Reevaluation of the C-51 Basin Rule Number: C-13412

Technical Memorandum # 4: Rule Development

September 2004

FIGURE 2-1

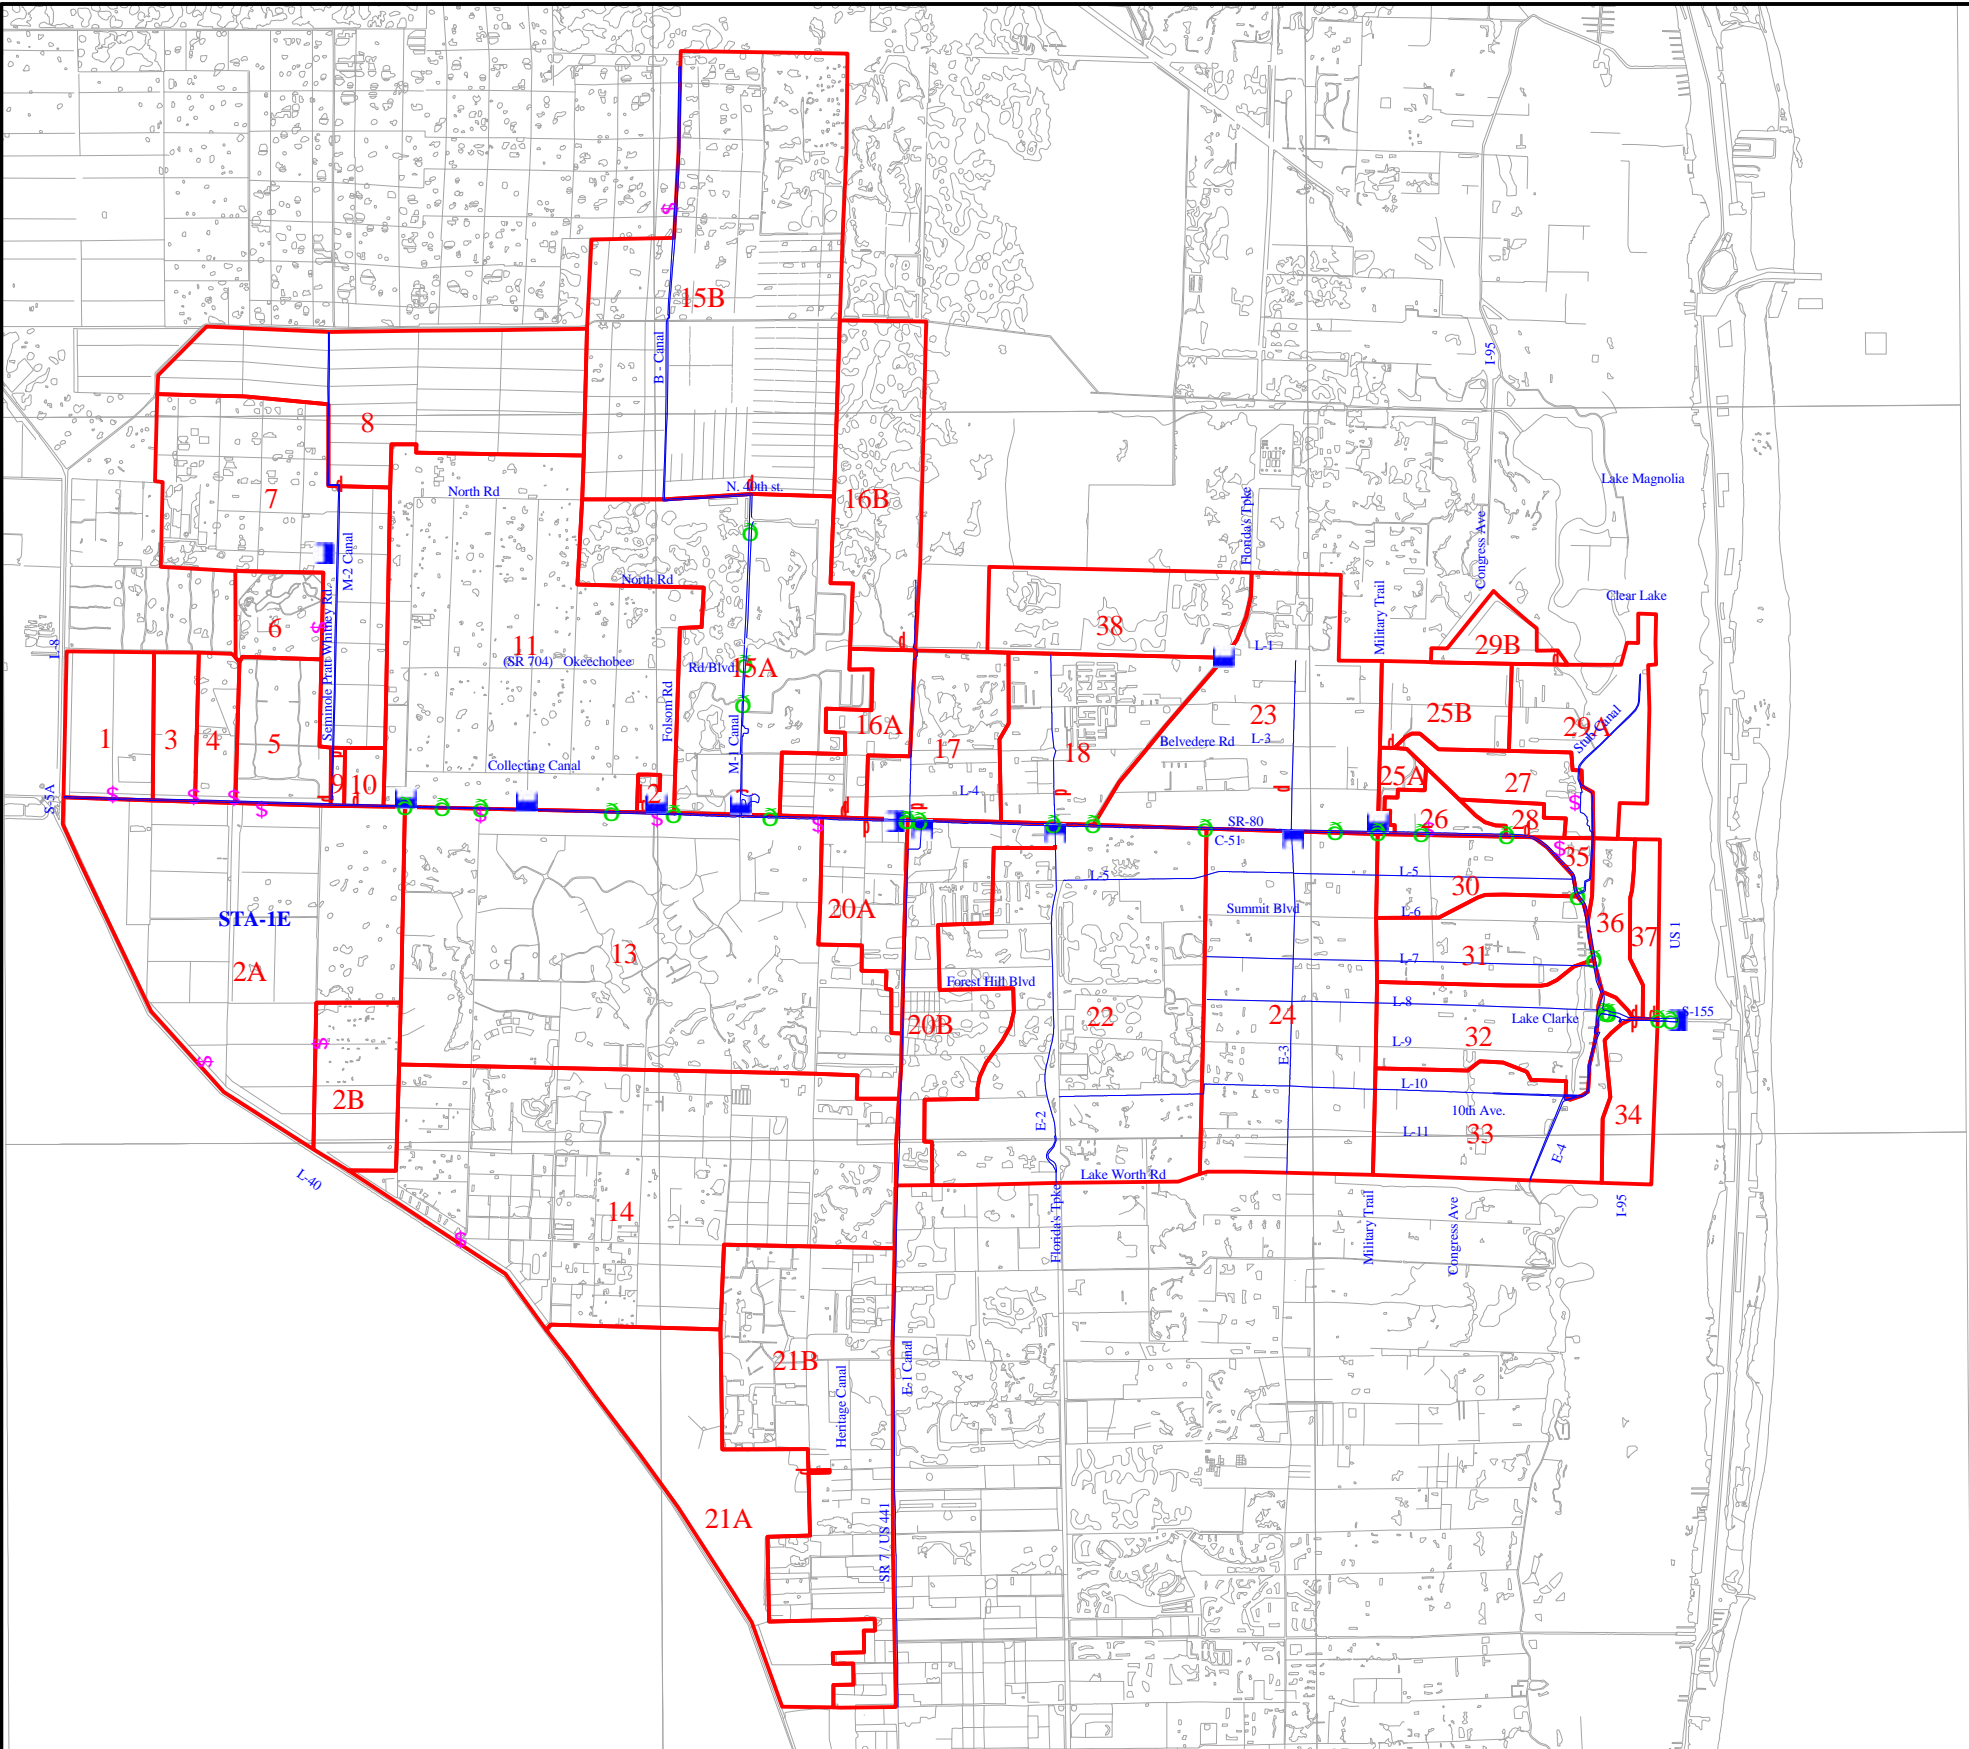
SA #2A: 3 pump stations were input to the model while the schematic drawing provided with the report only shows 1.

Response: Figure 2-1 (Storm Water Conveyance System) and Figure 3-2 (Nodal Diagram) show all 3 pump stations correctly as modeled and as they existed during the calibration period.

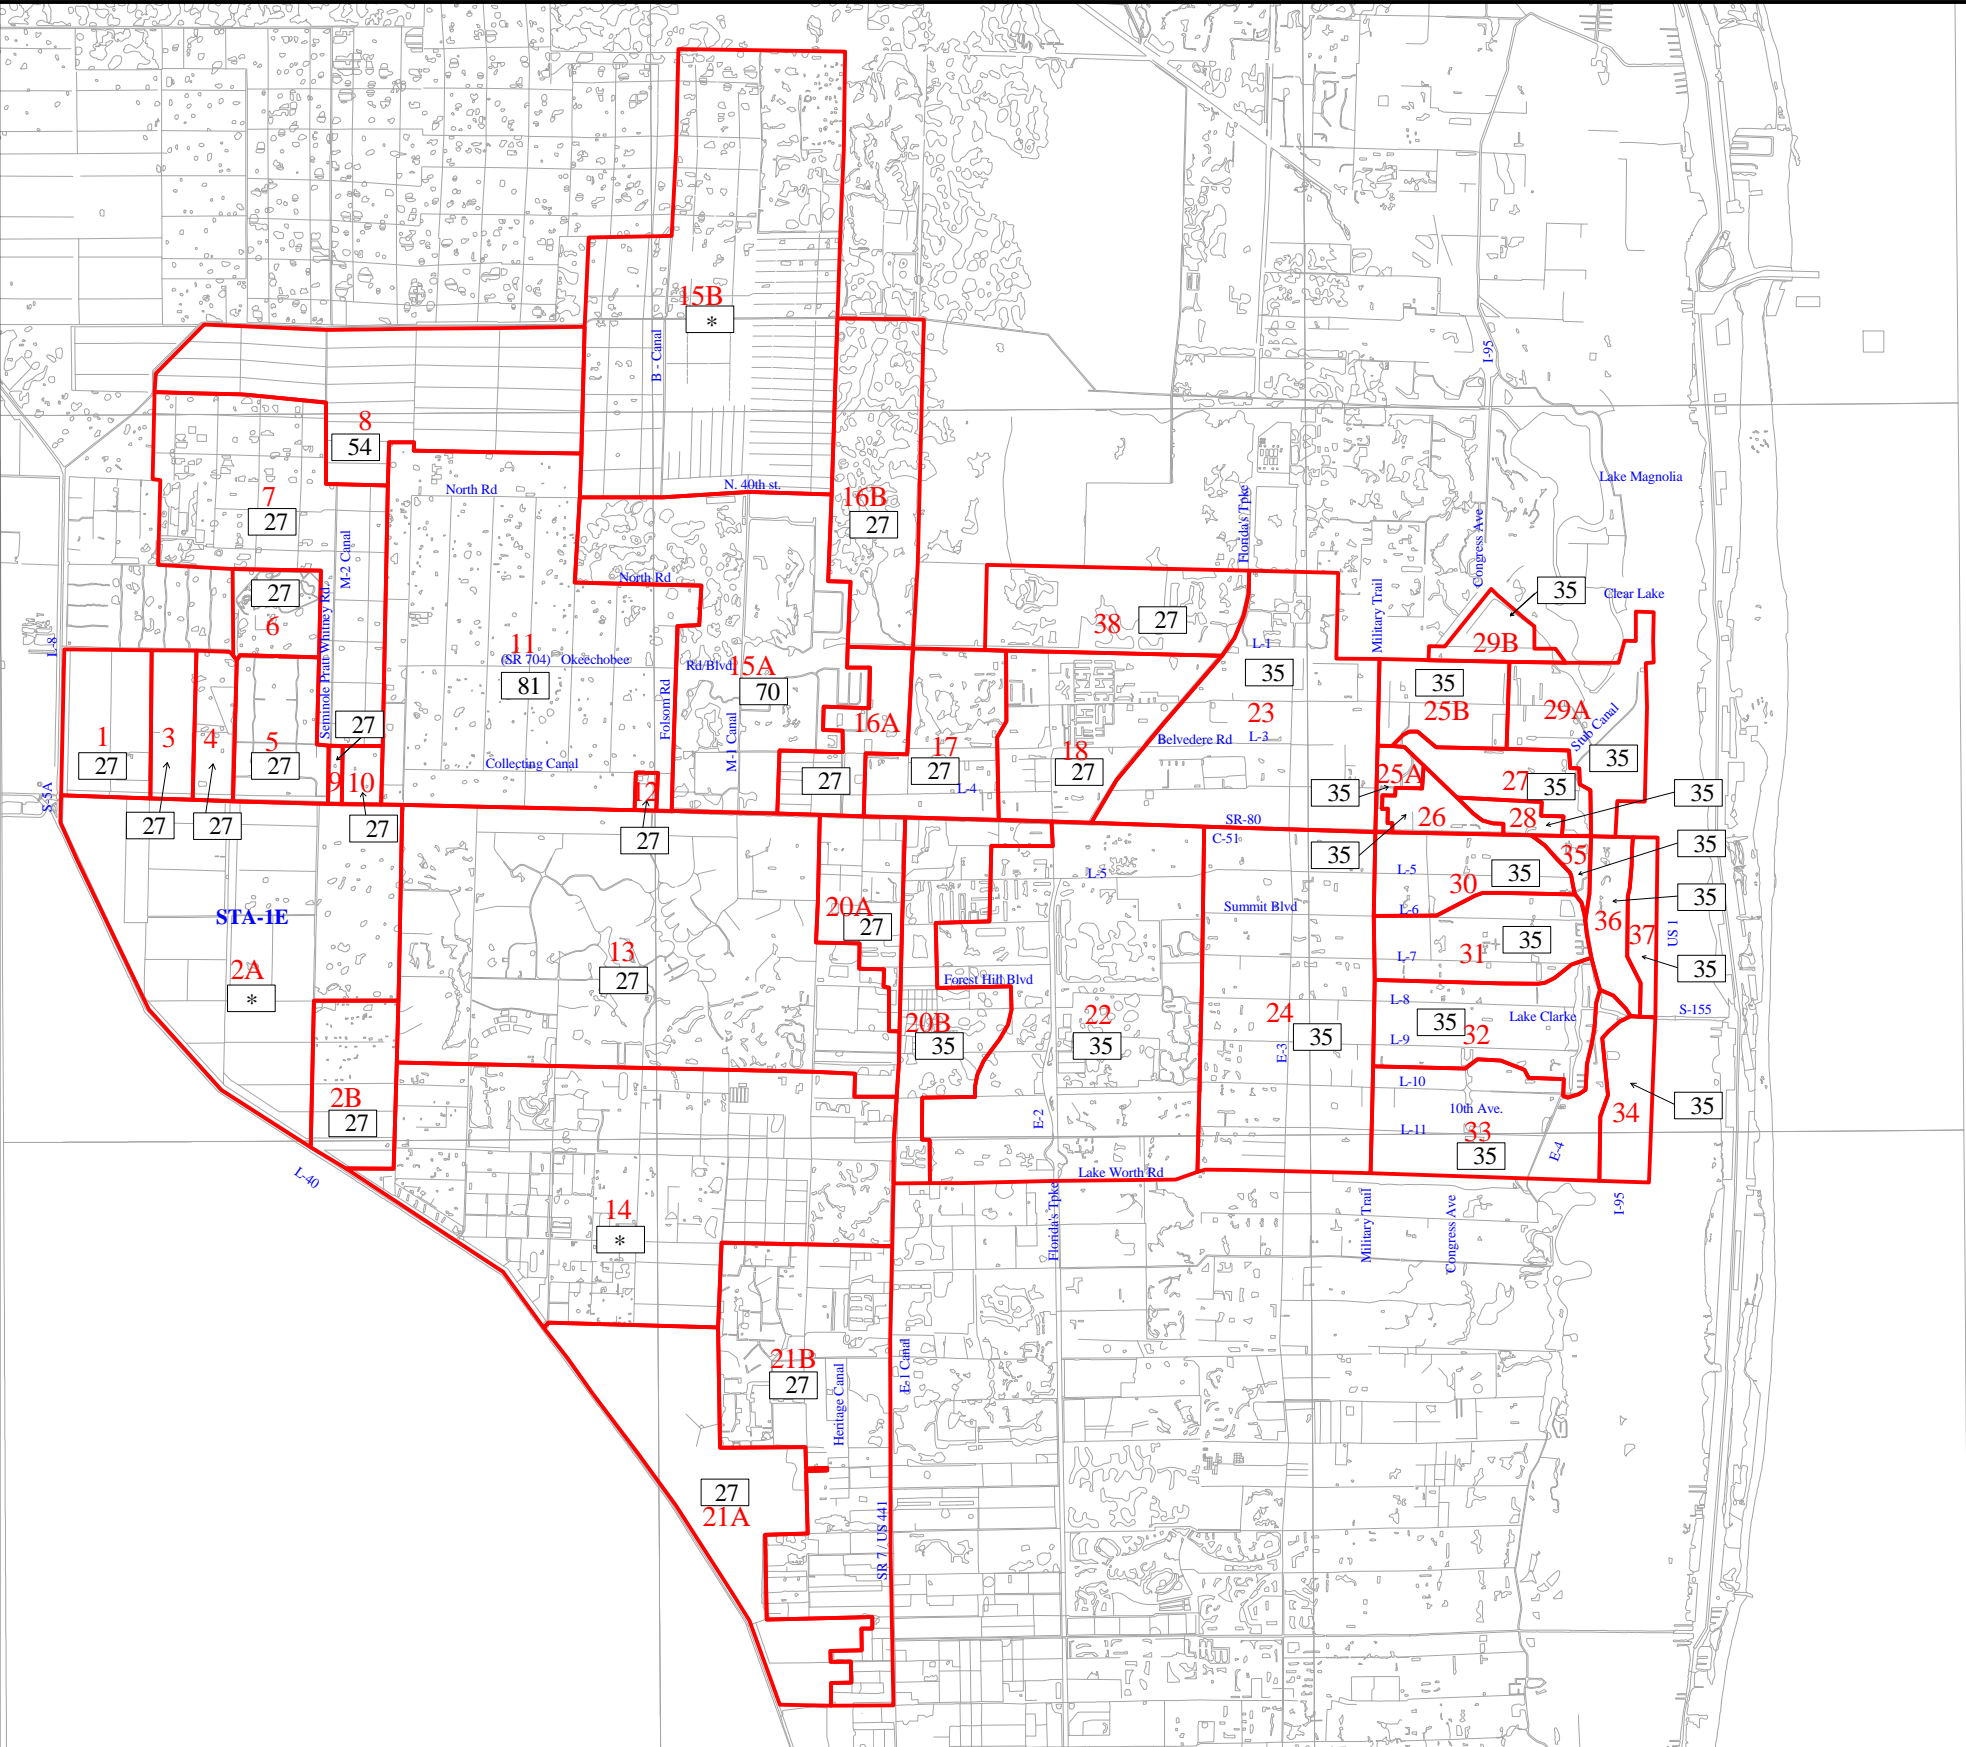
- Also please add the following sentence to this paragraph: “Figures 41-8 and 41-9, referenced in the rule language below, correspond to figures presenting the same information as Figures 4-1 and 4-2 in this report.

Response: Revised as suggested.

DTM Creation Flowchart

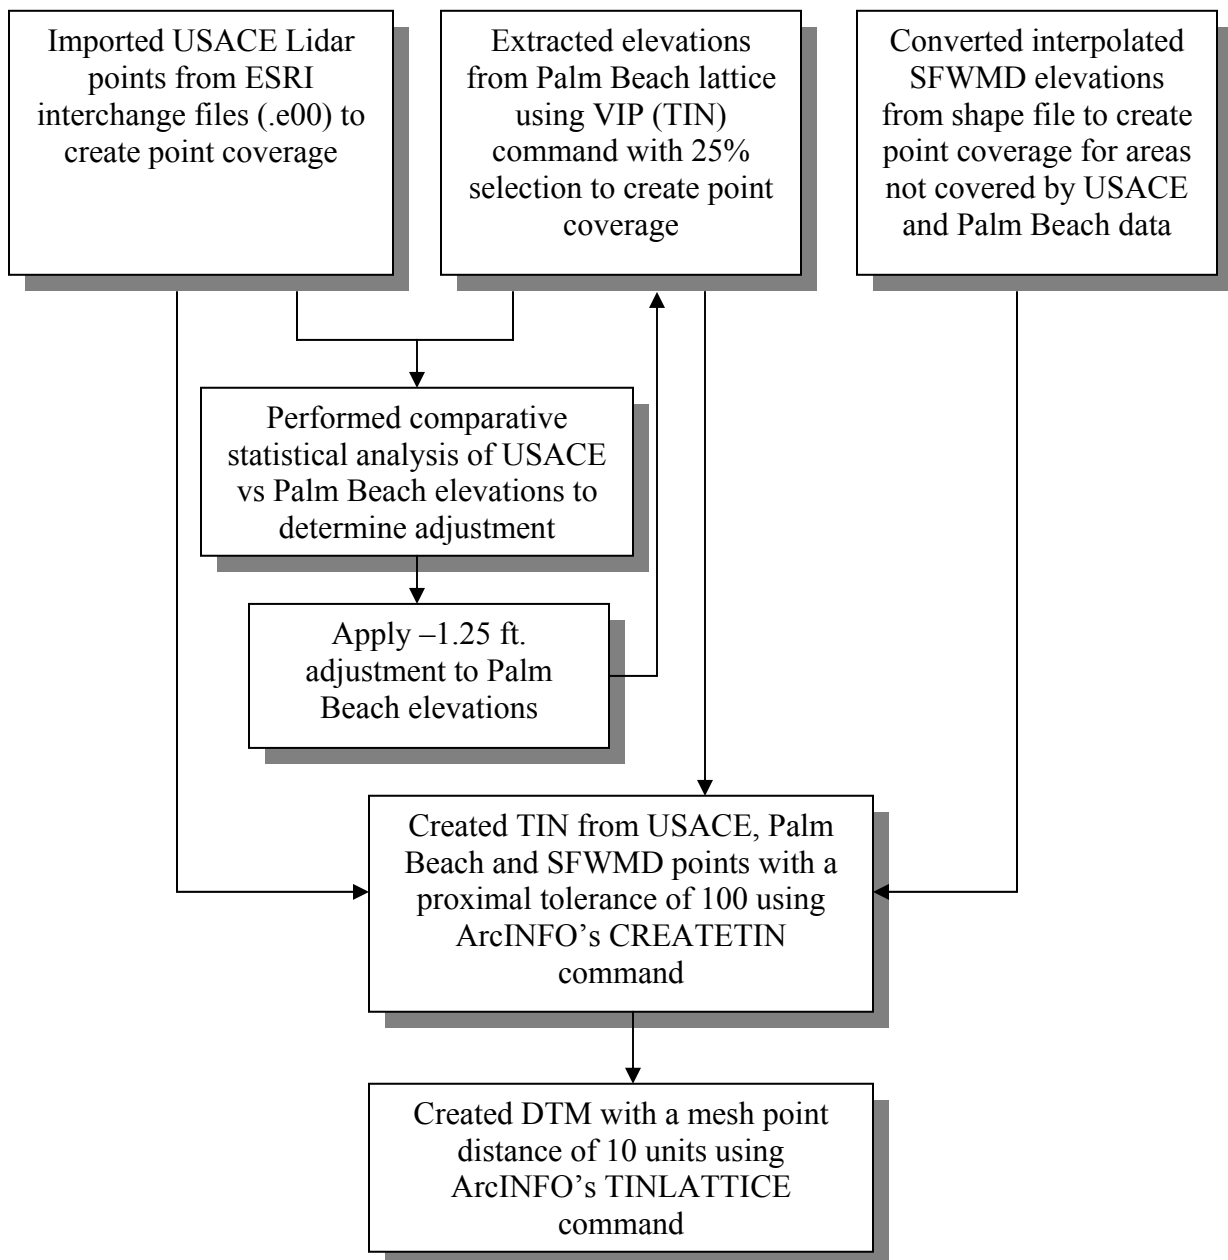
- First sentence: Revise to “A Digital Terrain Model (DTM) of the C-51 basin was developed...”
- To be consistent with the report all references to the United States Army Corps of Engineers should be USACE. This appendix uses both COE and ACOE – all should be USACE. This applies to the text of the full appendix as well as the flow chart. Where Army Corps of Engineers is spelled out for the first time in the first bullet, add United States Army Corps of Engineers.
- Second Page: What is SPSS? Please spell out in the text.
- Third Page, flow chart: Some of the text in the boxes is cut off. Please adjust appropriately.

Response: Revised as suggested. SPSS is the name of a statistical software, which has been restated with better clarity.
